project:
Tenant Finish
for
Brighton Recovery
Campus
4905, 4911, 4915, 4925,
4931, 4953 South 900 East
Salt Lake County, Utah

1	JANUARY 3, 2017	SECOND SUBMITTAL FOR EACH SEPARATE BUILDING PARCEL
2	JANUARY 6, 2017	ADDENDUM #2-BUILDING 'C'
3	JANUARY 17, 2017	ADDENDUM #4-BUILDING 'B'
4	FEBRUARY 24, 2017	ADDENDUM #7-BUILDING 'A'
5	MARCH 20, 2017	ADDENDUM #8-BUILDING 'A'

EXISTING
SITE PLAN

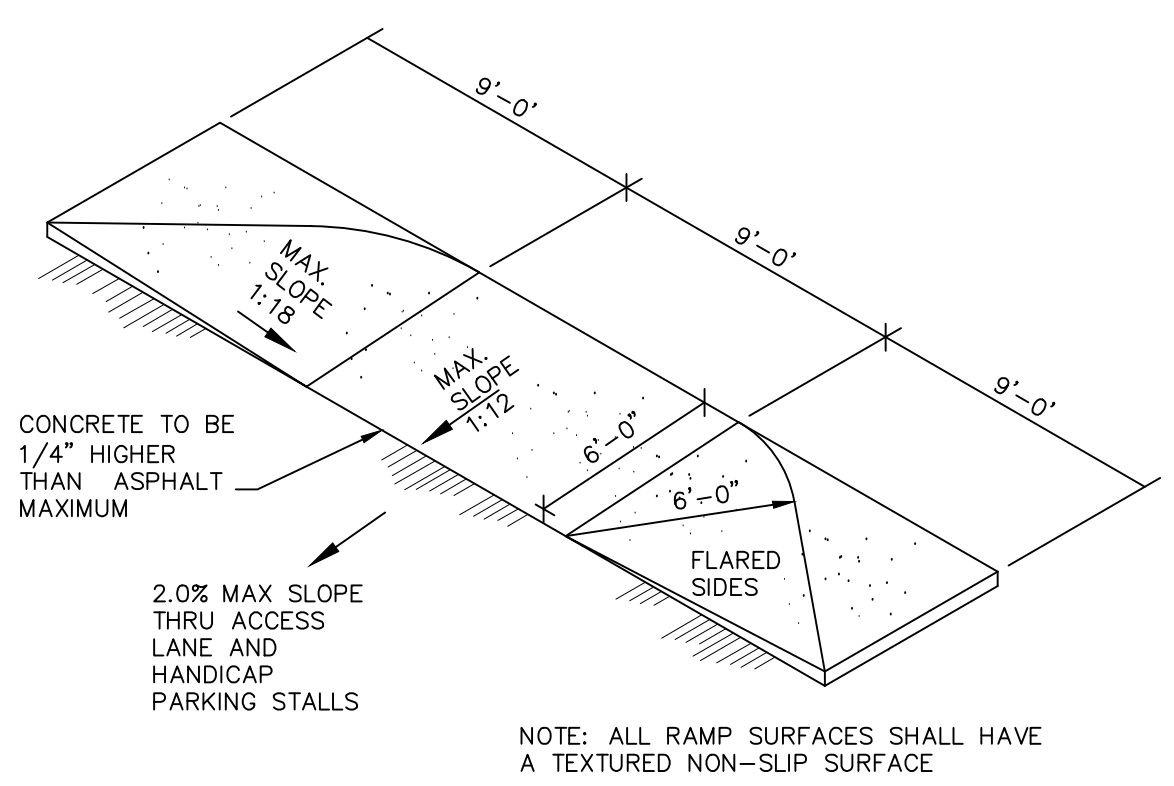
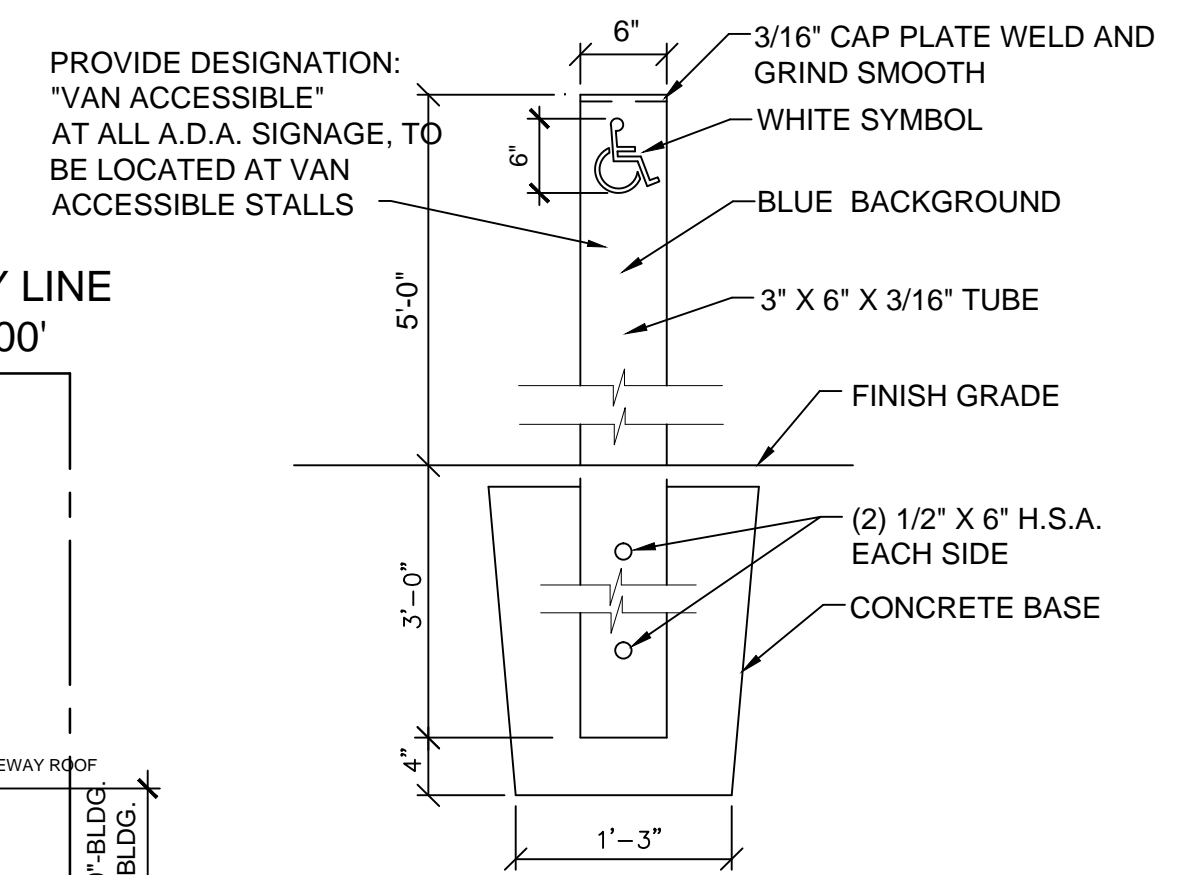
NOTE: ENTIRE EXISTING PARKING AREAS, INCLUDING DRIVEWAYS TO RECEIVE NEW ASPHALT OVERLAY AND NEW PARKING STALL STRIPING, AS PART OF ADDENDUM #4 -SEE NEW SPECIFICATION SECTION ON SHEET A1.2.

NEW ONE HOUR FIRE RATED WALL ASSEMBLY TO BE PROVIDED ABOVE NEW CEILING, ABOVE EXISTING EXTERIOR WALL STRUCTURE, WITHIN THE ROOF STRUCTURE OF EACH EXISTING BUILDING. THIS WILL OCCUR WHERE EXISTING ROOF OVERHANGS ARE ADJACENT TO OTHER EXISTING BUILDING ROOF OVERHANGS, AND WHERE EXISTING BREEZEWAY ROOFS OCCUR. WALL ASSEMBLY TO EXTEND FROM BOTTOM OF EXISTING ROOF OVERHANG TO BOTTOM OF EXISTING ROOF SHEATHING. UL DESIGN U305, OR U314: 5/8" SHEETROCK FIRECODE CORE PANELS, OR 5/8" SHEETROCK ULTRALITE PANELS FIRECODE X, OR 5/8" FIREROCK PANELS ON 2X4 WOOD STUDS @ 16" OR 24" O.C. (ONE HOUR FIRE RATED CONSTRUCTION). THIS ALLOWS A FIRE RATED SEPERATION BETWEEN EXISTING BUILDING CANOPIES AND BREEZEWAY ROOF STRUCTURES. THIS FIRE RATED WALL ASSEMBLY WILL EXTEND FROM THE TOP OF THE ROOF BEARING WALL STRUCTURE, TO THE BOTTOM OF THE EXISTING ROOF SHEATHING.

ALSO PROVIDE NEW FIRE SPRINKLING SYSTEM AT ALL EXISTING BUILDING EXTERIOR ROOF OVERHANG SOFFITS AND BREEZEWAY SOFFITS. FIRE SPRINKLING SYSTEM TO BE NFPA 13 SYSTEM, AND TO MEET ALL LOCAL JURISDICTION AND NATIONAL REQUIREMENTS. REFER TO SHEET P02 FOR FIRE SPRINKLING SYSTEM REQUIREMENTS. SYSTEM TO BE DESIGNED FOR EXTERIOR APPLICATION

PLEASE REFER TO SHEET A4.6 FOR UNITED FIRE AUTHORITY REVIEW COMMENTS AND REQUIREMENTS.
